SUBJECT: SAFETY RECALL: BELLOWS PIPE ON 2012 - 2013 MCI D SERIES COACHES WITH CUMMINS 2010 ISX ENGINE

Ref.: **NHTSA # 13V-142**
Transport Canada # 2013-121
MCI Service Bulletin 397

Service Bulletin No. 397

<i>MODEL</i> D Series Coaches	<i>TYPE</i> Field Change Program	<i>SECTION/GROUP</i> 8-Engine	<i>DATE</i> April 25, 2013
<i>SUBJECT</i> EXHAUST SYSTEM BELLOWS PIPE			
<i>CONDITIONS</i>

Figure 1.

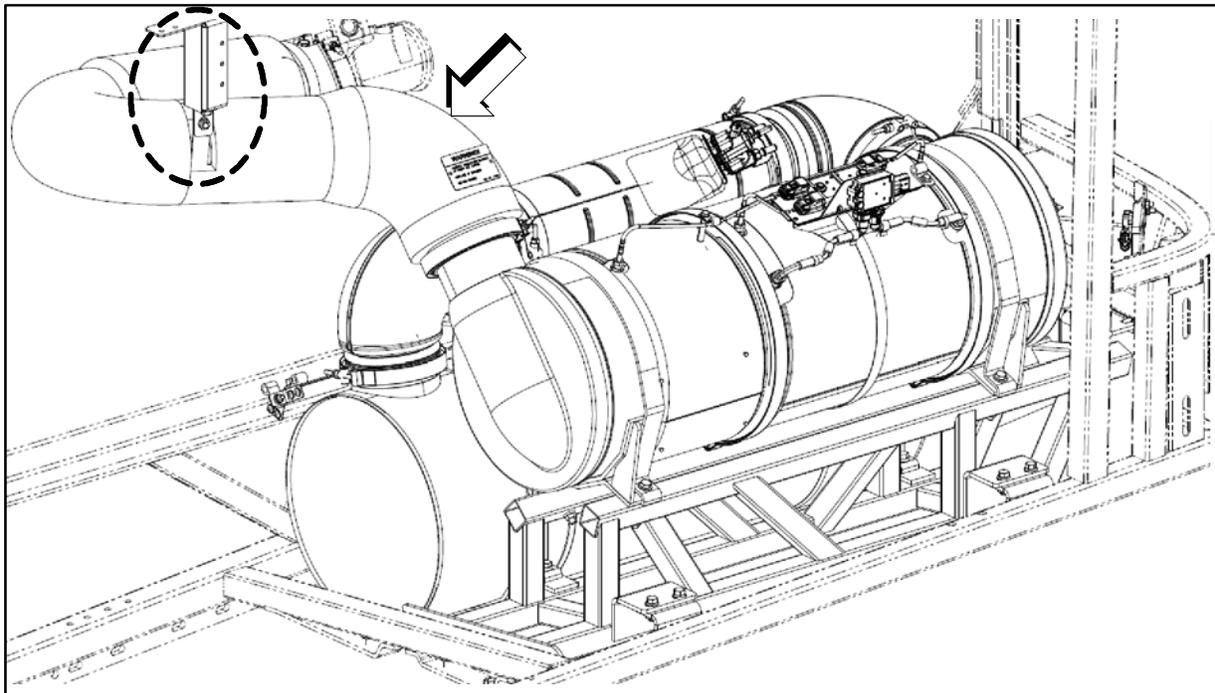
1. Turn the main battery disconnect switch to the OFF position.
2. Chock both sides of the tires.
3. Open the engine compartment doors and locate the exhaust system bellows pipe (refer to Figure 1).

4. Remove and retain the blanket on the turbo side of the installation, and place the blanket on a workbench.
5. Locate and remove the existing two (2) capscrews and locknuts from the pipe assembly bracket where it attaches to the coach frame (refer to Figure 1). Remove and retain the mounting hardware to be re-installed at a later step in this procedure. Discard the existing pipe assembly bracket.
6. On the turbo and exhaust side of the installation, untighten the clamps from the exhaust pipe.
7. Remove the bellows pipe and place on a workbench.

Figure 3.

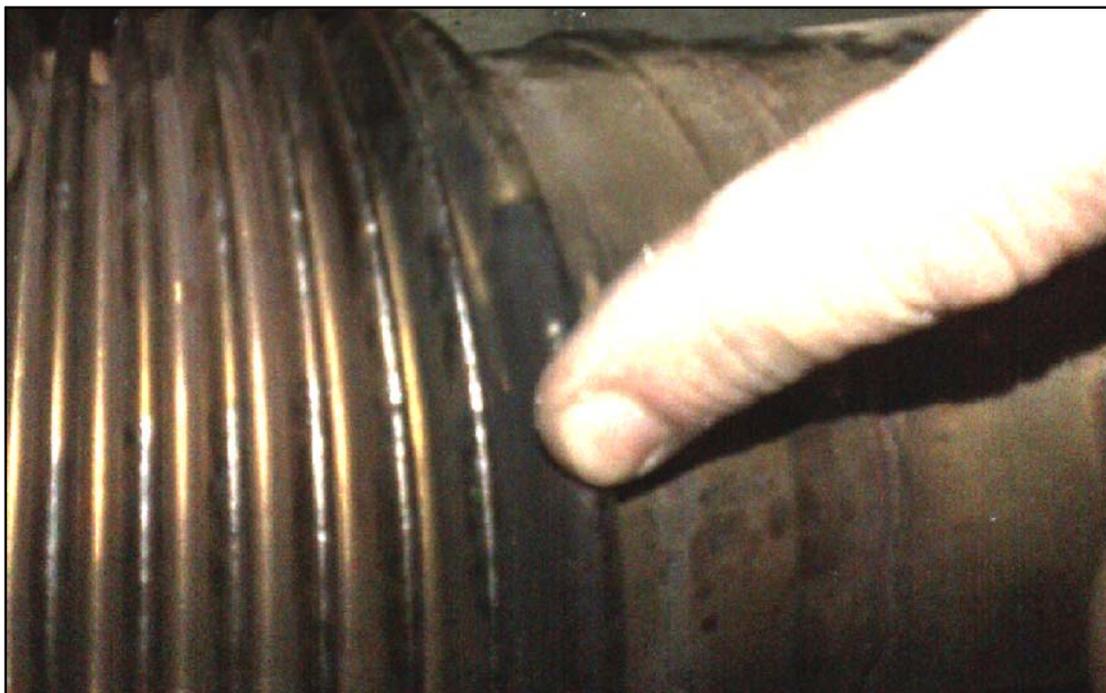
2. the bellows pipe has a crack or evidence of breakage (refer to Figure 3); or

If any one (1) of the above three (3) conditions exists, a new bellows pipe, p/n 08-20-1786, is required to be installed in Step 8. of this procedure.

Figure 4.

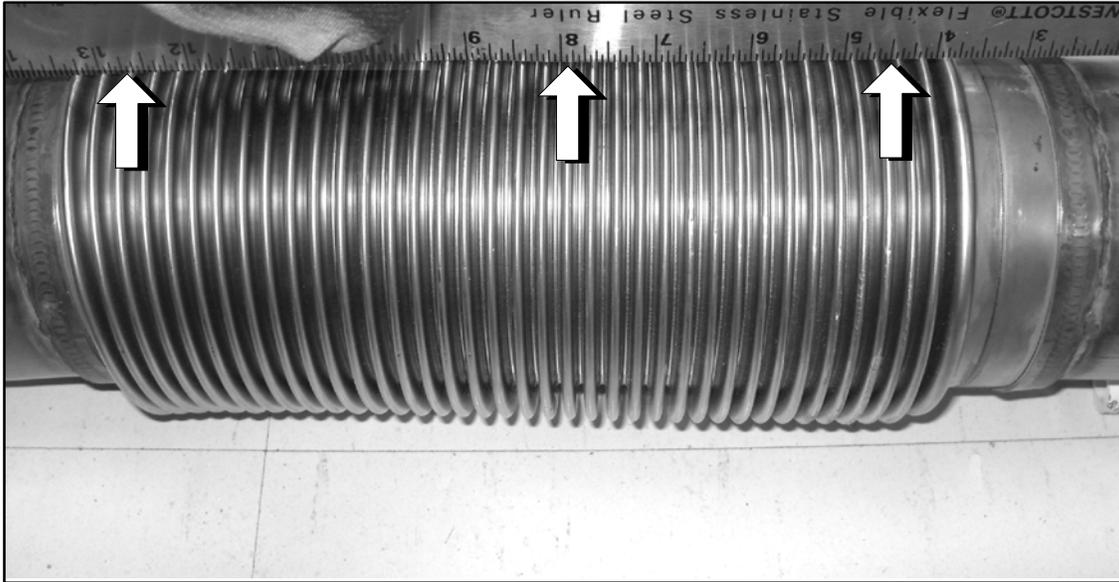
3. *the bellows pipe has a gap of more than 0.250 inch between a straight edge and the bellows due to permanent deformation, when a straight edge is positioned over the bellows at multiple positions around the circumference (refer to Figure 4).*

Figure 6.

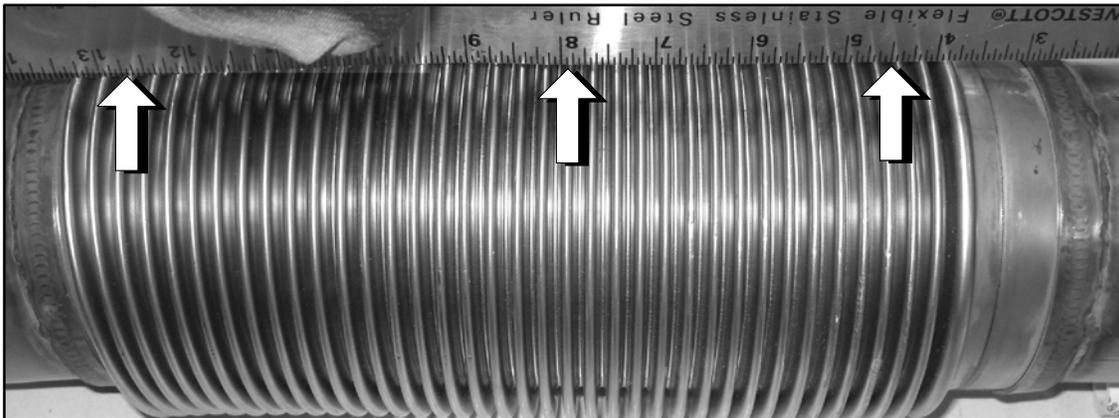
9. Position a straight edge over the bellows at multiple positions around the circumference to ensure there is no deformation or gaps (refer to Figure 6) prior to tightening the clamps. Orient as required to achieve no deformation or gaps.

Figure 7.

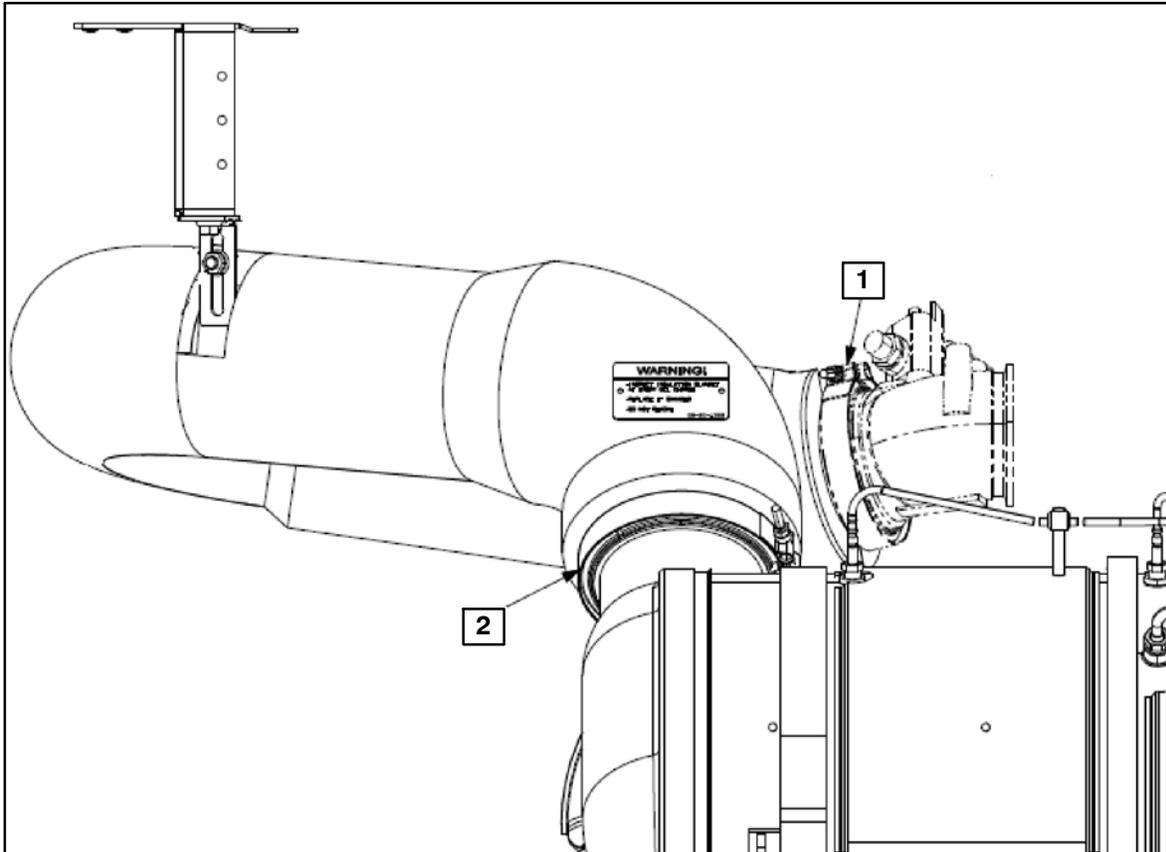
10. Orient the exhaust pipe seat, and tighten the clamps to the exhaust pipe per the following steps:
- a. Torque the clamp, Item 1 in Figure 8, to 86–95 in-lbs. Torque the clamp, Item 2 in Figure 8, to 100–110 in-lbs.
 - b. Tap around the clamps in three (3) places with a rubber mallet,
 - c. Re–torque the clamps,
 - d. Tap around the clamps in three (3) places with a rubber mallet,
 - e. Re–torque the clamps.

<u>ITEM</u>	<u>DESCRIPTION</u>
1	Torque to 86–95 in-lbs
2	Torque to 100–110 in-lbs

Figure 8.

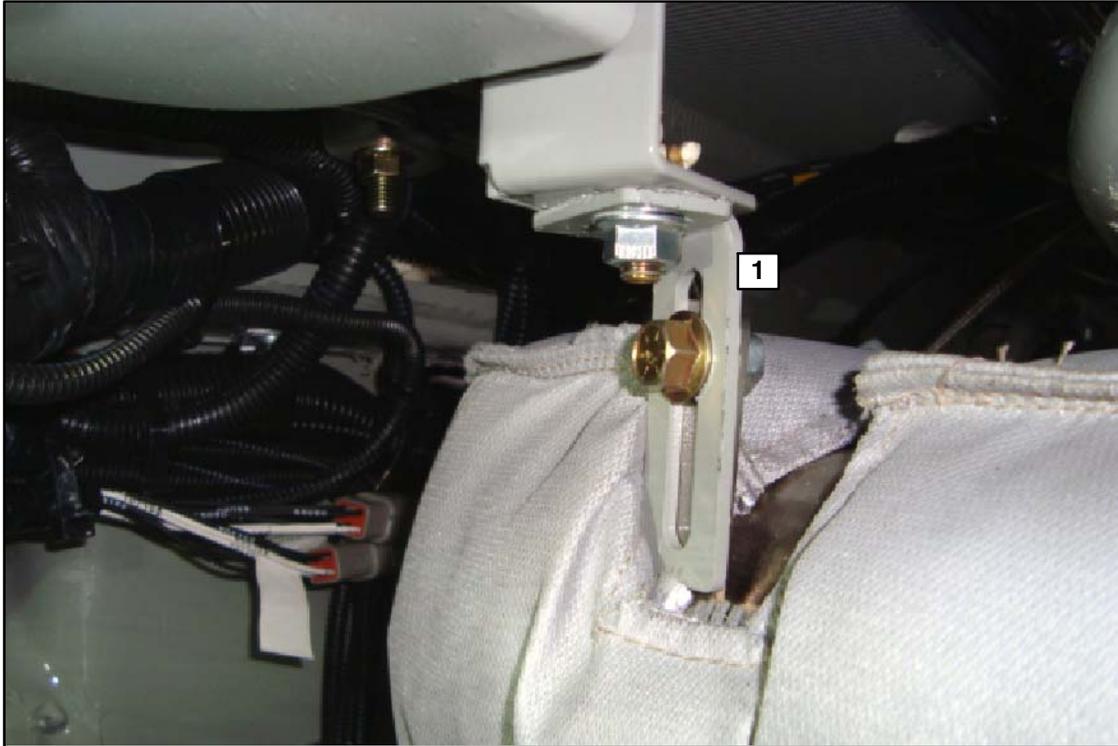
11. Locate the pipe assembly bracket where it attaches to the coach frame (refer to Figure 8).
12. Using the mounting hardware removed in Step 5. and new bracket, p/n 08-20-2350, secure the bracket to the coach frame. Torque to 33–37 ft–lbs.

ITEM	DESCRIPTION
1	Bracket, p/n 08-20-2350
